Bid Bulletin #04

PROJECT: Skinner Early Childhood Center
Bid Package #4
Omaha, NE

ADDENDUM G

Skinner Early Childhood Center
Omaha, Nebraska
RDG Project No. 2014.128.00, File 35.1

Sheet E4.0 – Enlarged Plans – Electrical

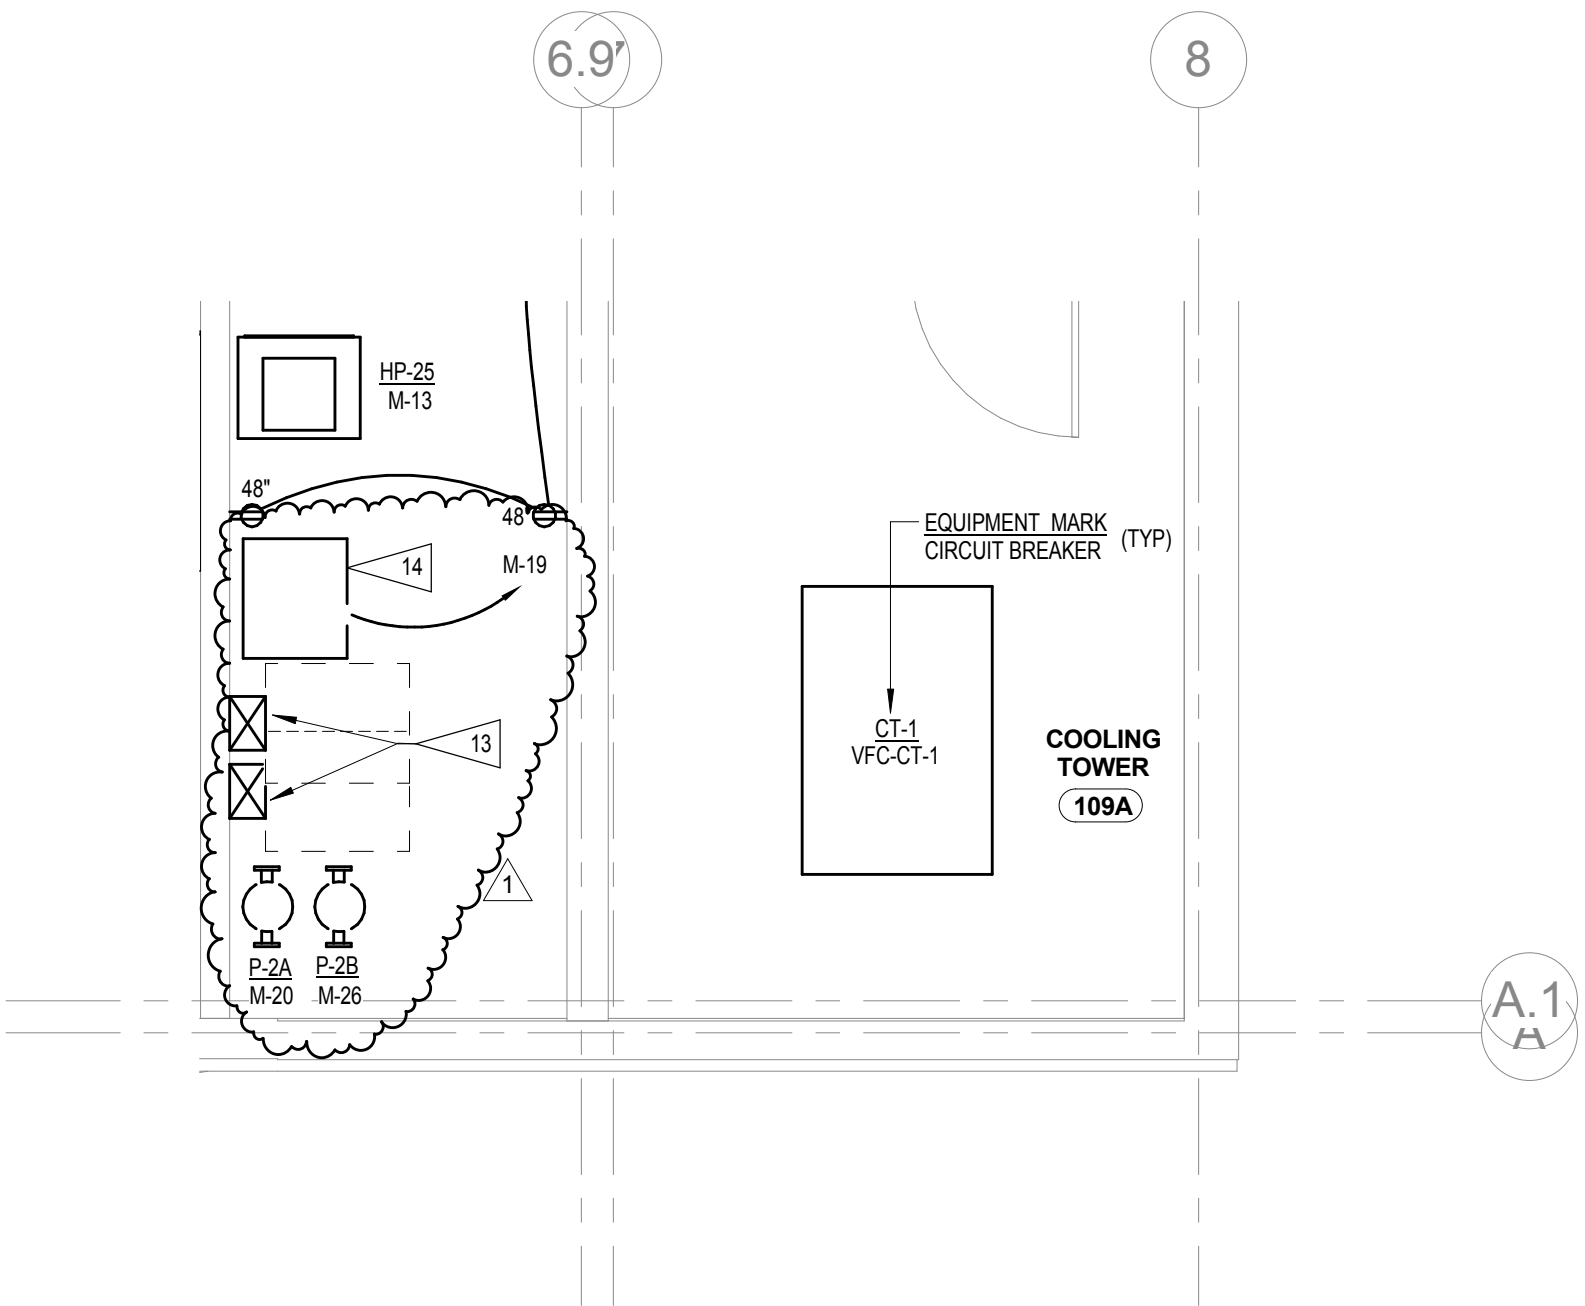
- A. Revise Flag Note 13 to indicate that stacking combination starters is acceptable if necessary. Flag Note now reads: “Provide combination starters for pumps P-2A and P-2B. Stack if necessary.”
- B. Add Flag Note 14 to indicate cooling tower filtration system on plans.
- C. Revised receptacle layout and added cooling tower filtration system and circuit on Enlarged Mechanical Room Plan – Power.

- 13 PROVIDE COMBINATION STARTERS FOR PUMPS P-2A AND P-2B. STACK IF NECESSARY.
- 14 COOLING TOWER FILTRATION SYSTEM.

EXTERIOR GREASE INTERCEPTOR

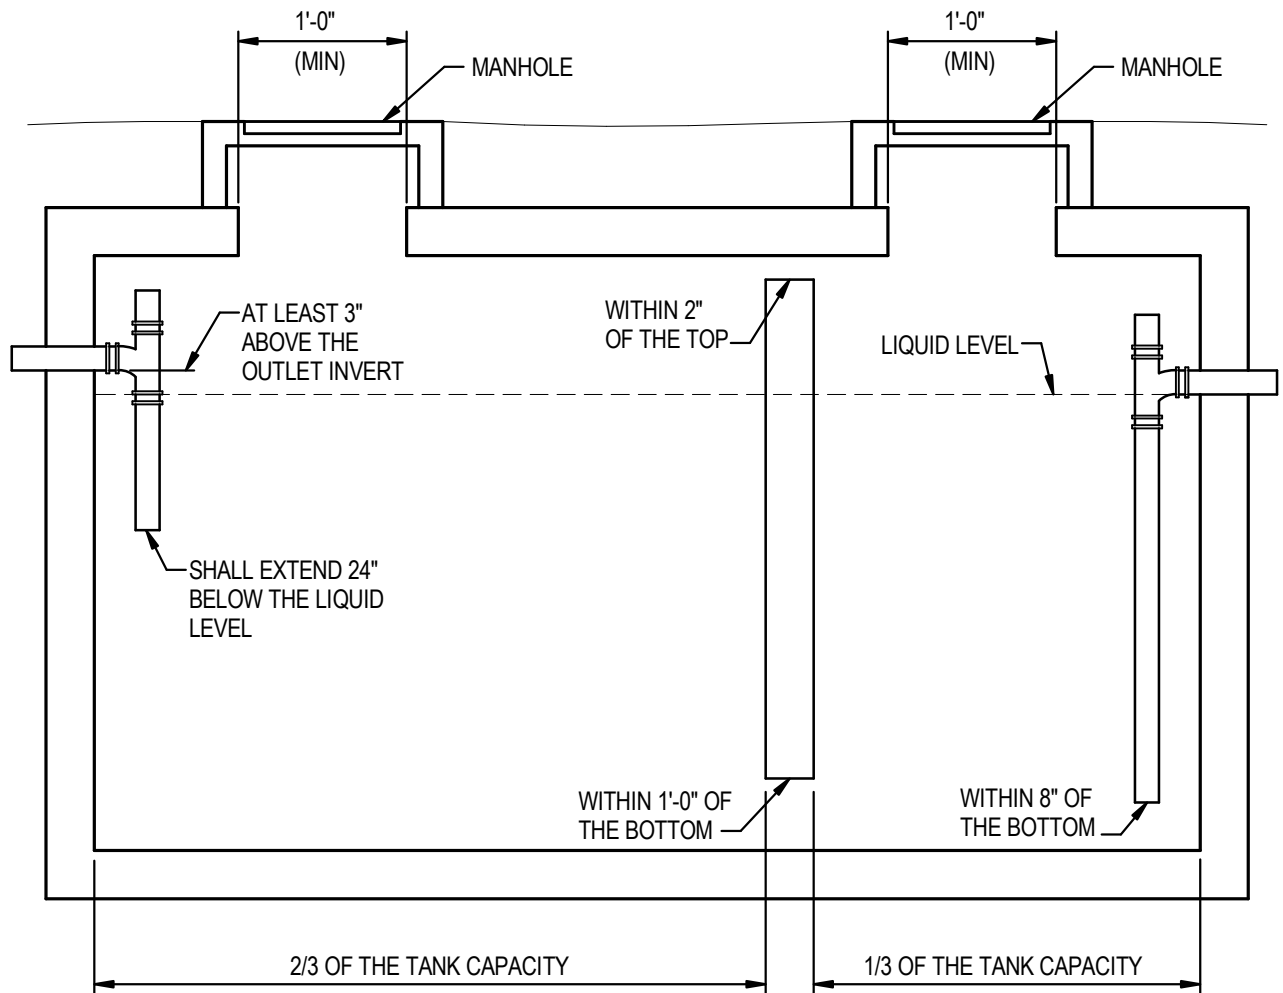
- A. Detail 6/P4.0 – Exterior Grease Interceptor: Modify detail to include sizing information. See revisions as indicated on attached Mechanical Sketch Sheet SDP-002.

NOTE:
SIZED IN ACCORDANCE WITH OMAHA PLUMBING CODE UNDER THE HOSPITAL/SCHOOL CATEGORY. 2.0x0.75x2.5x164 SEATS = 615 GALLONS. SIZED AT MINIMUM CAPACITY ALLOWED, 750 GALLONS.
